cherenkov
telescope
array

System Engineering

NectarCAM Progress Meeting, 6 & 7 April 2021

- CDMR Recommendations
 - MST Structure-Camera Interfaces & other External ICDs
 - Requirement Management and Design Verification
- Status & on going actions

Maintenance Tunnel used at Berlin

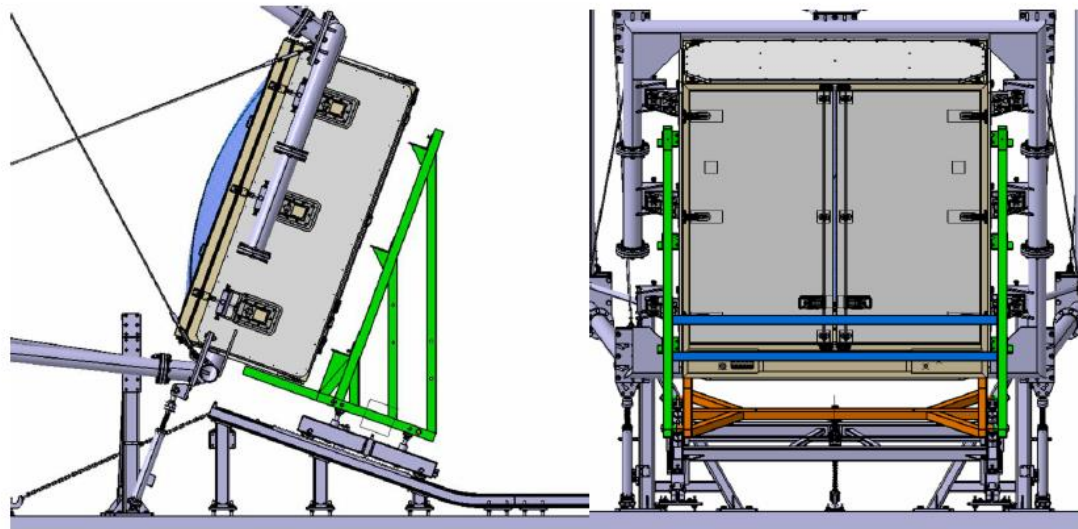
■ Maintenance tunnel

- Degradation of PMT & Plexiglas window performances with sun
- Maintenance tunnel required for camera front maintenance
- Design maturity versus environment to be demonstrated
- On site workshop (re)discussed with CTAO
